KINCH SUBDIVISION

Construction Drawings

PCD FILING NO. MS-204

ENGINEERING RECORD DRAWINGS

PLAN & PROFILE
KINCH COURT

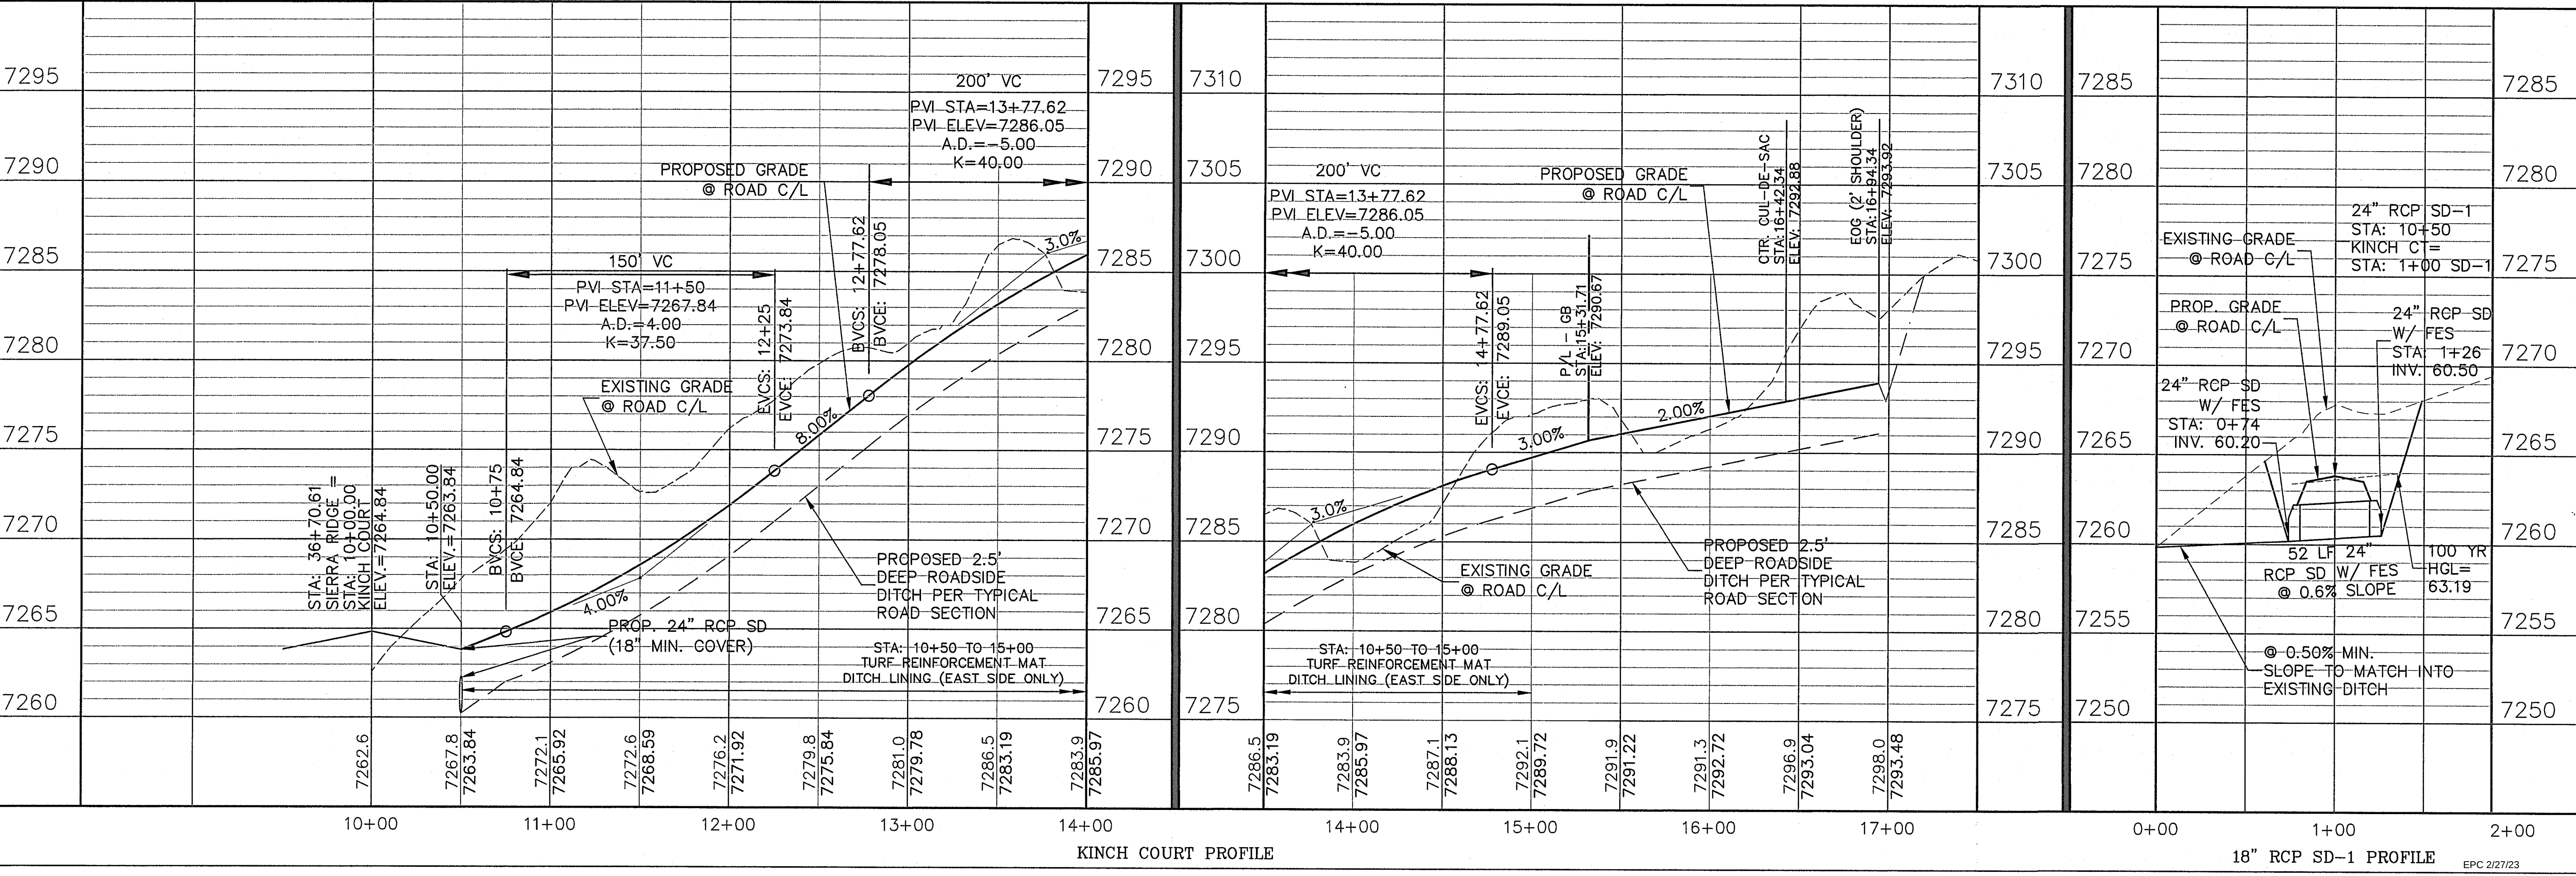
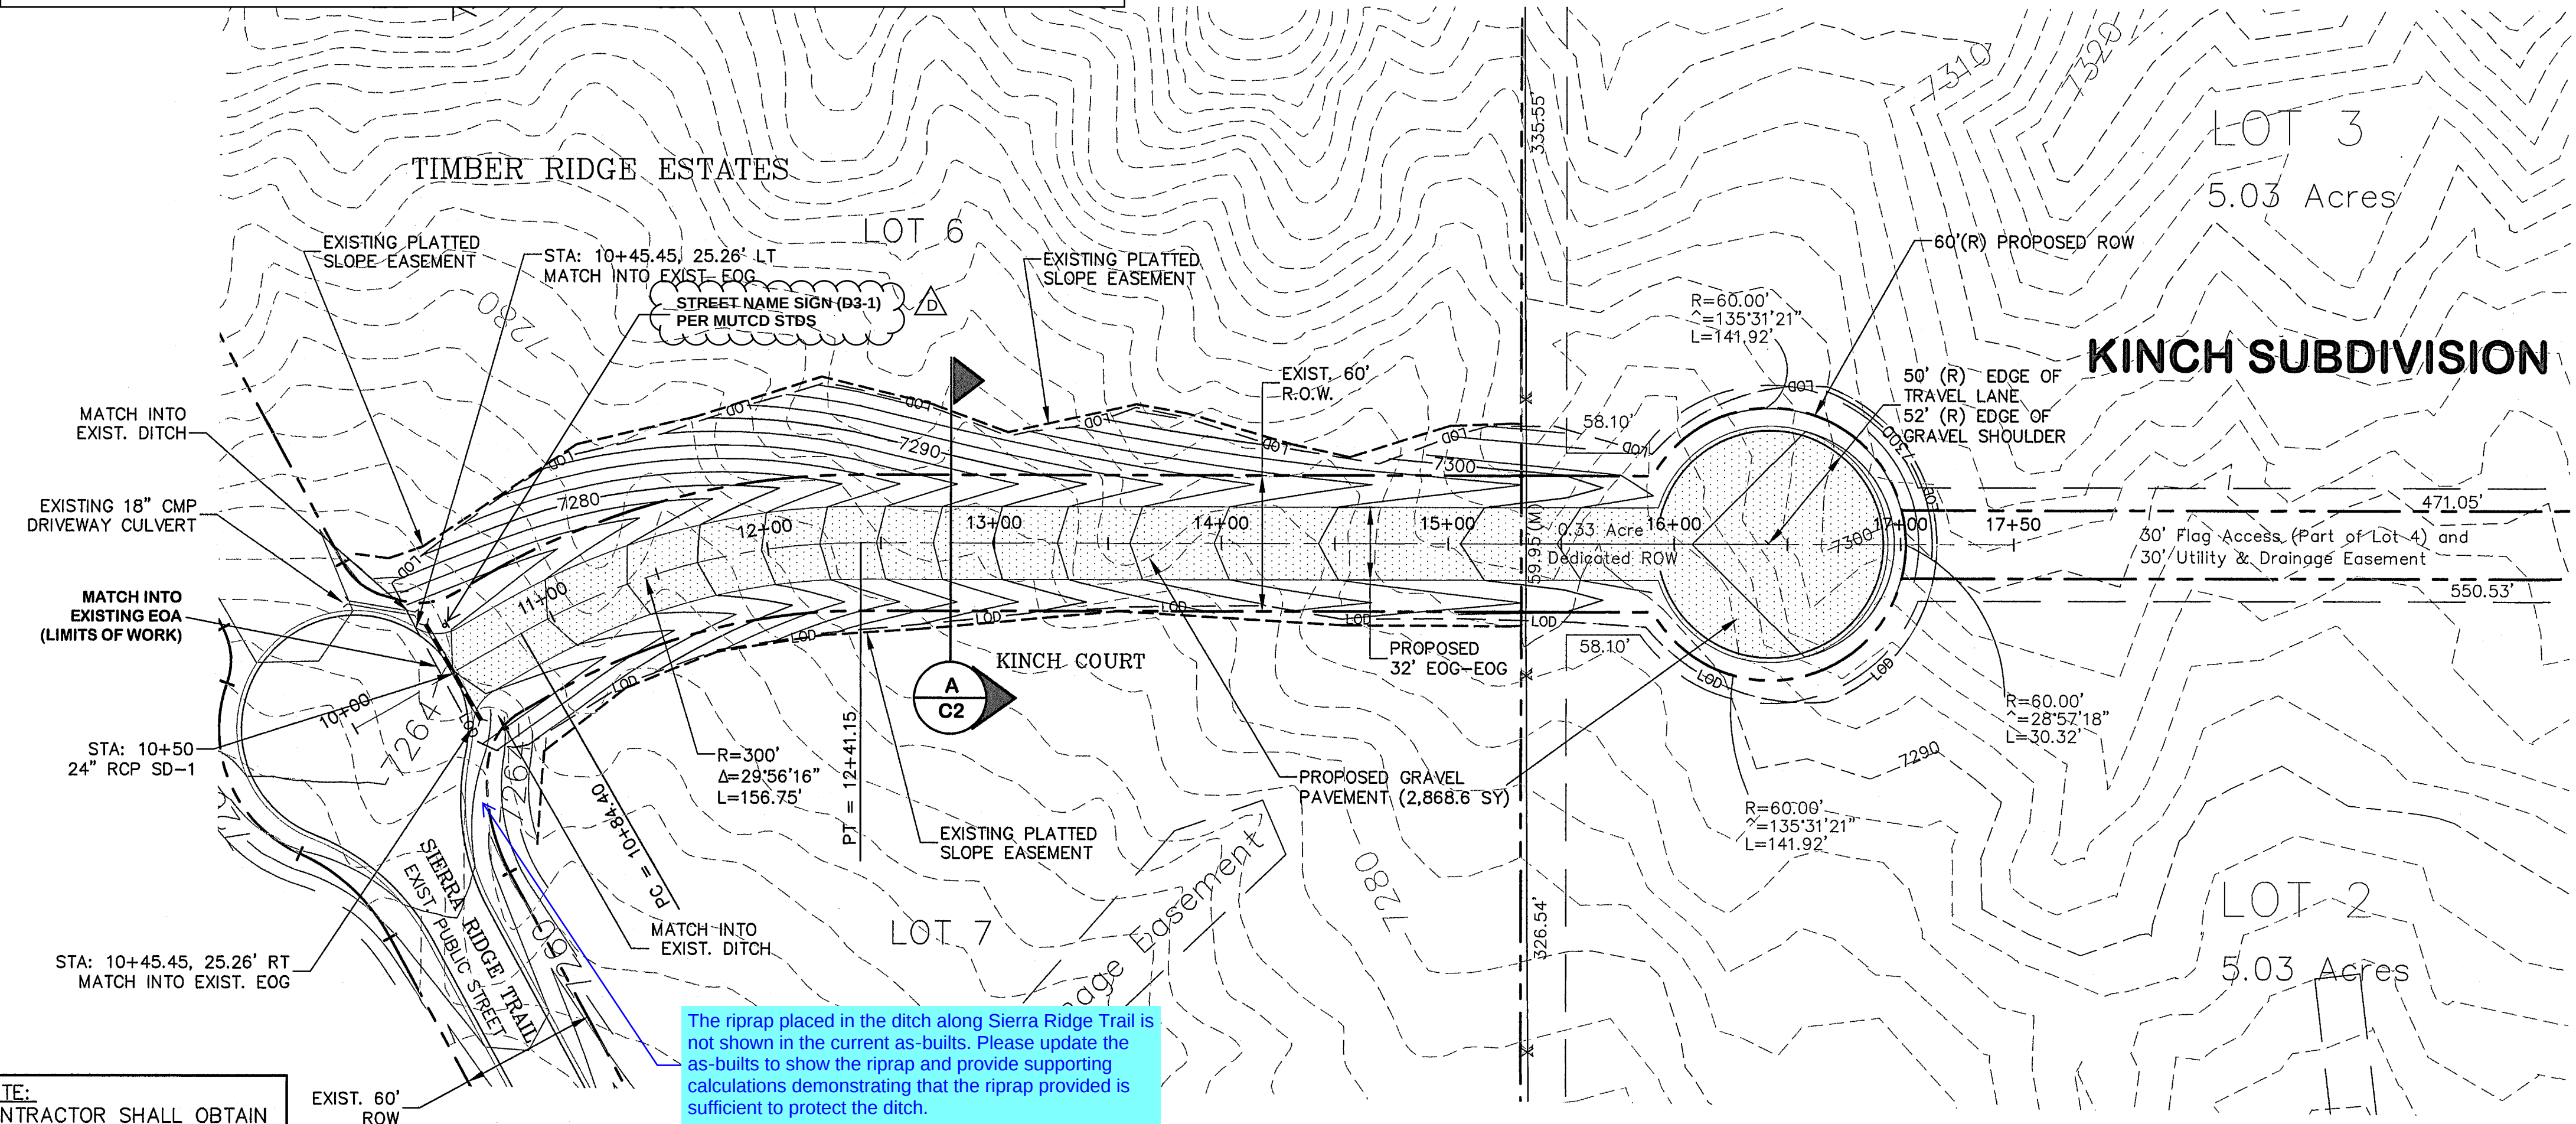
The riprap placed in the ditch along Sierra Ridge Trail is not shown in the current as-builts. Please update the as-builts to show the riprap and provide supporting calculations demonstrating that the riprap provided is sufficient to protect the ditch.
